National Grid

AMENDMENT REPORT

CUSC Proposed Amendment CAP046

Mandatory Frequency Response

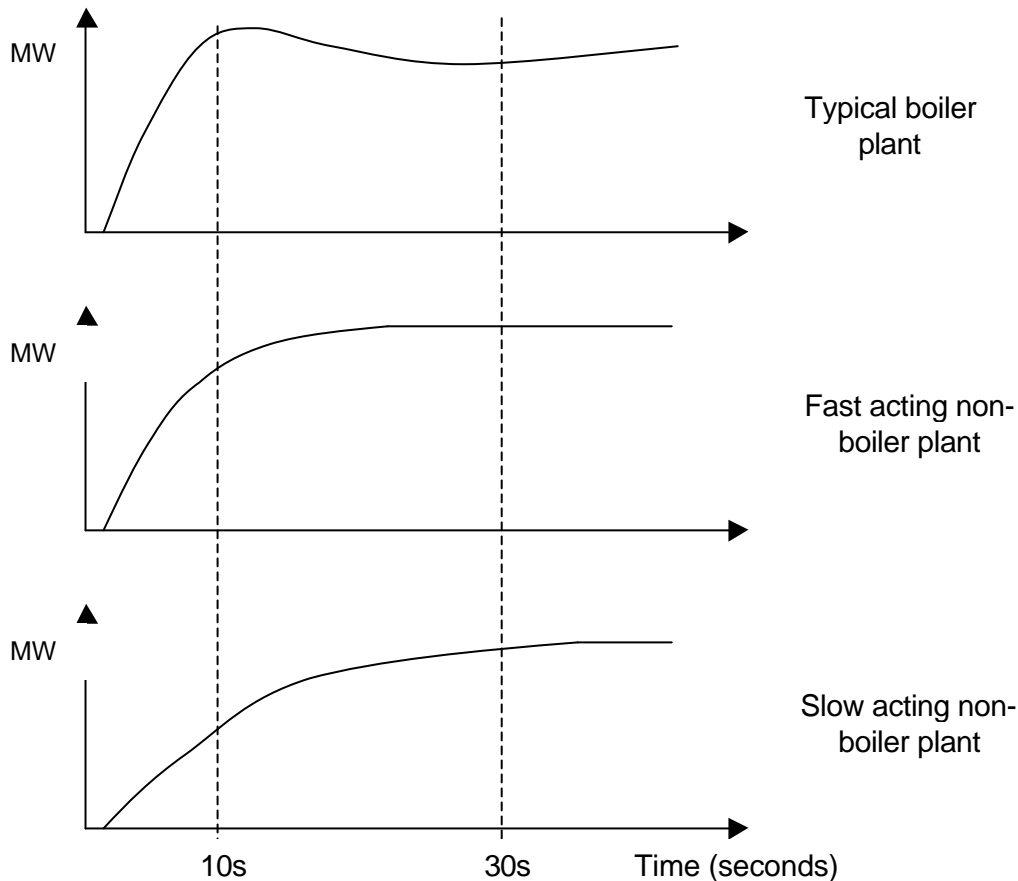
- 4.3 It is a Grid Code requirement that all licensed generation is capable of operating in frequency sensitive mode. However, the output characteristics from different types of generating plant can vary quite significantly according to its primary fuel type and control system design. Typically, conventional 'boiler-plant' has a capability for storing significant quantities of energy that can be delivered in a short duration (i.e. primary response from coal or oil fired generating plant). However, in contrast, delivery from Hydro and CCGT generating plant is dependent on the rate of increase of primary fuel flow, meaning that for 'non-boiler-plant', any response energy is typically delivered in a more gradual manner. These typical response delivery characteristics are shown graphically below:

- 4.4 The use of primary and secondary response values to calculate the response energy delivered over a period of time can therefore be inappropriate for certain plant types. From the graphs above it can be seen that the Primary response value can be significantly lower than the steady state response output for slow acting non-boiler plant.
- 4.5 The matrix tables were not designed for the purpose of accurately calculating the volume of response energy produced by a generator over a period of time when it is operating in frequency sensitive mode and responding continuously to minor frequency fluctuations. To overcome this issue it is proposed that an additional set of Power Delivery Data Tables are contained in the MSA and used in the response energy payment calculation. The values in these tables
